APPENDIX A-10: COMMENTS AND RESPONSES TO
COMMENTS
OAKLAND HARBOR TURNING BASIN
OAKLAND, CALIFORNIA

January 2024

Figure 10. Total TEU Forecast to 2050 in All Scenarios¹⁰

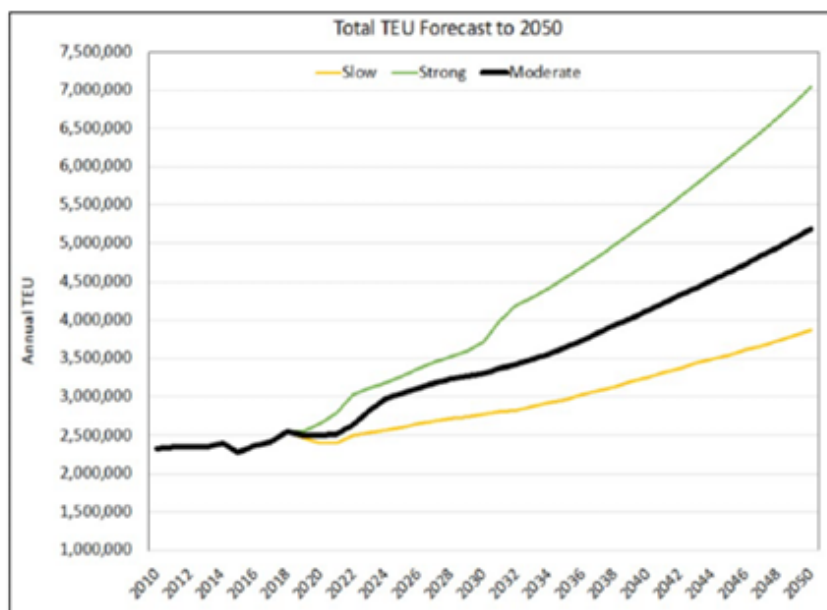
The statements made by the Army Corps in the EA are not entirely accurate. Although the use of larger ships to transport cargo to and from the Port may result in a reduction in ship emissions, which should have already been evaluated in the EA, the air quality and GHG analysis presented in the EA do not account for impacts from the increase TEU throughput that would result after two existing turning bases have been modified. Figure 10 of the EA shows that the Army Corps projected the number of TEU passing through the Port under a strong and weak economy. The figure indicates TEU throughput at the Port sharply increasing after 2029, which is the date the Project is expected to be completed. It is clear from this figure that the Port's future growth depends on the widening of the existing turning basins to allow ships with greater TEU capacity compared to the ships that presently call at the Port. To this end, modifying the existing turning basins would impact the freight activities at the Port. Although there will be fewer ships calling to the Port, due to the larger TEU capacity of the ships, the terminals at the Port would very likely have to acquire more onsite equipment to facilitate the transport of the TEUs off and on ships, and increase the number of heavy-duty diesel-powered trucks and locomotives to transport these TEUs out of the Port. Based on CARB's review of the air quality and GHG analysis and health risk assessment that the Army Corps prepared for the Project, there was no evaluation of the potential environmental impacts associated with the Project's impact on the Port's freight activities.

California Air Resources Board (CARB)		
Comment Number	Response	Location in IFR
CARB – 1	<p>The IFR/EA explains in Section 5.7 that the Project will not induce growth, or otherwise increase cargo throughput. It is for that reason that no modeling of freight activities is justified because the Project will have no freight impacts. The project’s reductions in vessel transit and emissions are an expected benefit but are unrelated to the fact that the Project won’t impact freight activities. Further, the Project’s proposed construction timeline is not directly related to the independent growth projection referenced in the comment letter. The graph shows the baseline estimation of total TEU forecast to 2050, growth expected to occur with or without the project. If those growth projections end up being accurate, vessel calls are expected to increase as well, but with Project conditions, larger, newer ships would carry more cargo allowing for more efficient navigation. The study does not support a causation connection between the growth in this graph and the Project and it is wrong for CARB to assume there is one. The air quality and greenhouse gas analyses account only for the construction emissions for the Project and documents the reduction of idling hours, thus the reduction of emissions from vessels. See Section 6.13 and 6.14 and GC-1.</p> <p>Additionally, CARB incorrectly assume that ship size determines cargo quantity. Instead, the amount of cargo is determined by the market and demand. Large vessels already call the Port and terminal operators manage the loading and unloading of both large and small vessels today. Terminal operators routinely adjust operations to manage and control changes in container volumes related to holiday surges and shortened work weeks due to no-work holidays. The existing conditions which include terminal operators adjusting to servicing varying container volumes temporally is anticipated to continue to meet the projected future container vessel fleet mix. The Project was properly scoped and analyzed in accordance with all project components. Whether there is significant cargo increases or not, the same amount of cargo can be brought on fewer, larger ships, or more, smaller ships. Either way, the same amount of cargo is brought to the Port. The turning basin expansions would allow for more efficient ship transit, allowing a greater number of larger ships to call at the Port more easily. The larger ships would carry more cargo and may spend more time at harbor than a smaller ship. Additional cargo is not anticipated from the widening of the turning basin, as the same throughput of containers is anticipated, and therefore no change to the Port's operations is included in any project alternative. As the greenhouse gas emissions analysis shows, it is anticipated that the Project will result in less greenhouse gas</p>	5.7: Evaluation of Potential for Induced Growth, 6.13: Air Quality, 6.14: Greenhouse Gases
